REMINGTON MODEL 700 AND MODEL SEVEN NOTICE

PRODUCT SAFETY WARNING AND RECALL NOTICE

REMINGTON MODEL 700™ AND MODEL SEVEN™ RIFLES

PHOTO 3

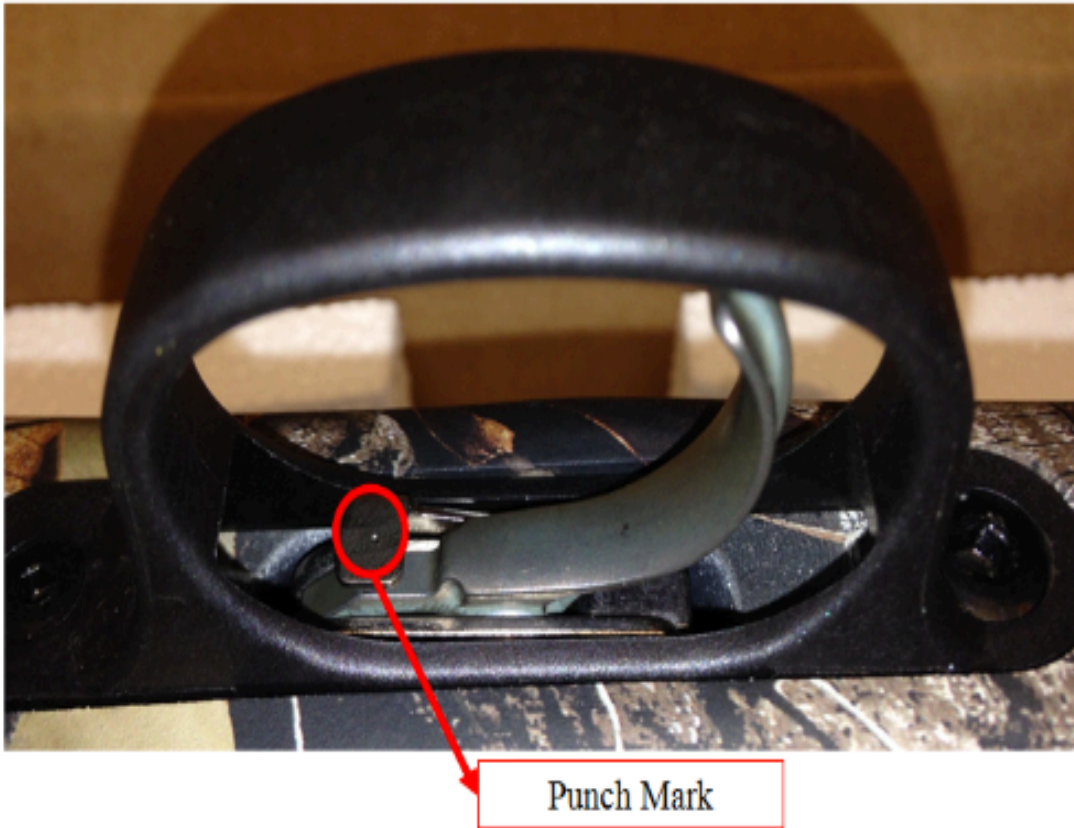
VERIFICATION OF CORRECTIVE ACTION: Upon return of your rifle, you will note a punch mark on the bolt release (see Photo 3 below). This mark confirms your rifle has been inspected and specialty cleaned under this recall program.

Remington has also corrected the XMP trigger assembly process to eliminate this problem in rifles made after April 9, 2014. Rifles made after April 9, 2014 will also have a punch mark on the bolt release.
